Sundry Print Report

Well Name: BAFFLED BCA FEDERAL COM

Type of Action Plug and Abandonment

Baffled BCA Federal Com 1 – NOI to P&A

Baffled BCA Federal Com #1

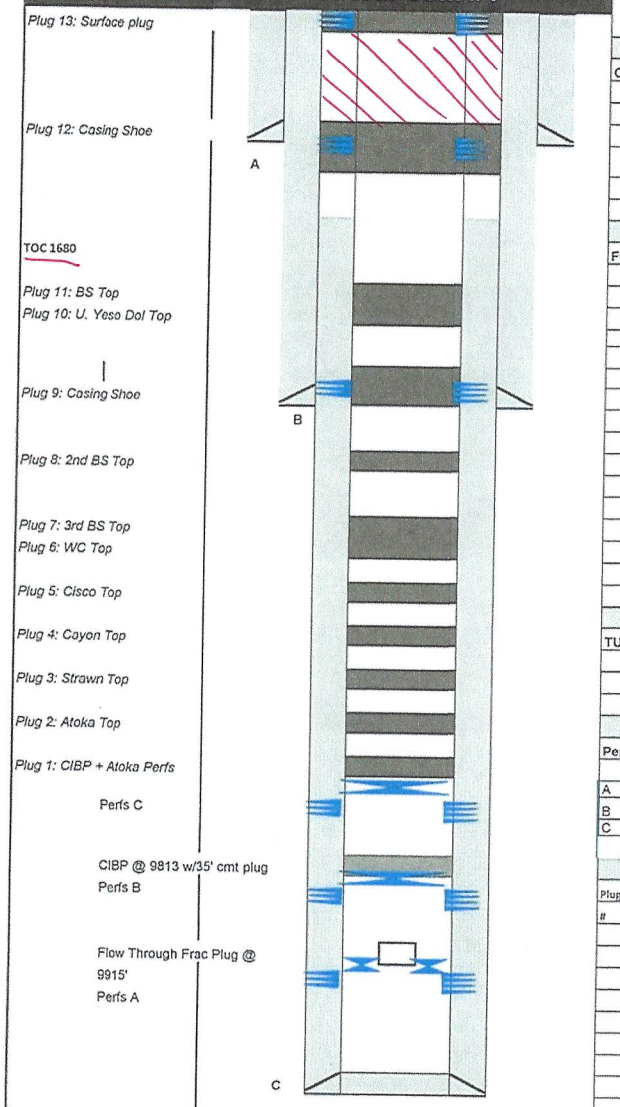
1. MIRU all safety equipment as needed. NU BOP. POOH with production equipment. Leak test CIBP
2. Set a CIBP at 9566 ft. Spot ~~4~~ sx Class H cement on top of CIBP to 9530 ft. This will cover Atoka perfs. 25 sx

13. Perforate at 435 ft. Spot a ~~31~~ 135 sx Class C cement plug from 435 ft – ~~333~~ surface ft. This will cover 13-3/8" casing shoe. WOC and tag. (In/Out)

14. ~~Spot a 16 sx Class C cement plug from 52 ft up to surface. Back fill as needed.~~ Verify @ surface
15. Cut off wellhead and install dry hole marker. Clean location as per regulated.

#	SX	Class	Top	Bottom	Δ	Notes	Tag	
1	4	H	9,530	9,566	36	Atoka Perfs	N	
2	25	H	9263	9489	226	Atoka Top	N	
3	25	H	8900	9126	226	Strawn Top	N	
4	25	H	8272	8498	226	Canyon Top	N	
5	25	H	8024	8250	226	Cisco Top	N	
6	25	H	7056	7282	226	WC Top	N	
7	25	H	6830	7056	226	3rd BS Top	N	
8	25	C	4018	4270	252	2nd BS Top	N	
9	25	C	3404	3656	252	Casing Shoe	Y	
10	25	C	2468	2720	252	U. Yeso Dol Top	N	
11	25	C	2216	2468	252	BS Top	N	
12	135 ~~21~~	C	0 ~~333~~	435	102	Casing Shoe	Y	Verify @ surface
~~13~~	~~16~~	C	0	52	52	Surface Plug	Y
